## **SHORNE PARISH COUNCIL**

### **RESPONSE TO HIGHWAYS ENGLAND SUPPLEMENTARY CONSULTATION (January to April 2020) REGARDING THE LOWER THAMES CROSSING**

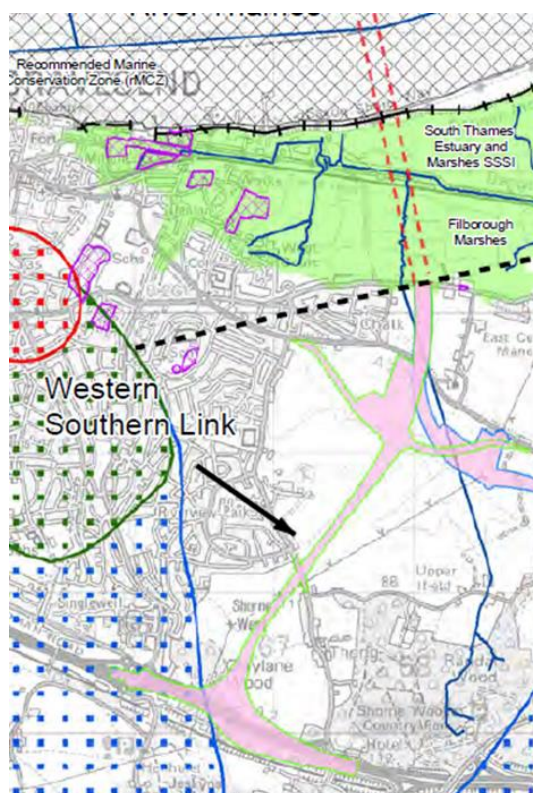
Overall, the water flows in the area are complex. In our previous submission we commented, based on the map that was in the 2016 consultation documents (see below), that the water supply to the North Kent Marshes SPA and the Ramsar Site arises in the higher ground in the Shorne Woods Country Park area and intervening farmland and drains northwards into the marshes. Many of the surface streams are seasonal, drying up in the summer, but some are permanent particularly that which passes Ifield Place Farm and then sinks. Its subsequent direction of flow is shown on the map as moving diagonally to the north west to pass between Chalk Church and Chalk Village, a route that will be transected by the LTC.

Our concern is that the 2016 map (and effectively all equivalent plans since) shows the LTC cutting across the line of this watercourse. The map was within the 2016 documentation but has not been included again since. We continue to have significant concerns about the possibility of interruption to/contamination of groundwater flows into the marshes.

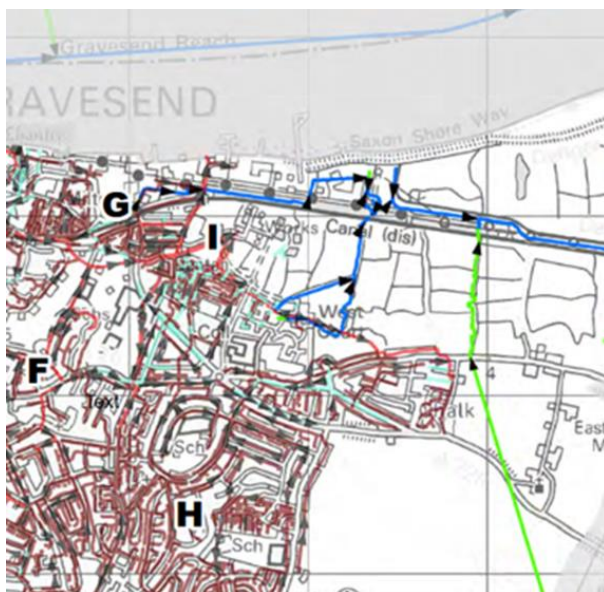
- e) The base map for the HE drawing is on the KCC website. It shows the direction of water flows, an important aspect which was omitted from the HE publication. This shows, as would be expected for a marsh, that the predominant directions of water flow are that: south of the railway line and canal water is flowing from south to north, and north of the railway line and canal it flows north to south, i.e. the opposite direction to the proposed LTC water discharge. Apart from other issues, clarification is needed as to the compatibility of the directions of flow with the LTC drainage proposal. These directions of flow are important to the health of the SPA and the flows cannot be disturbed or reversed.
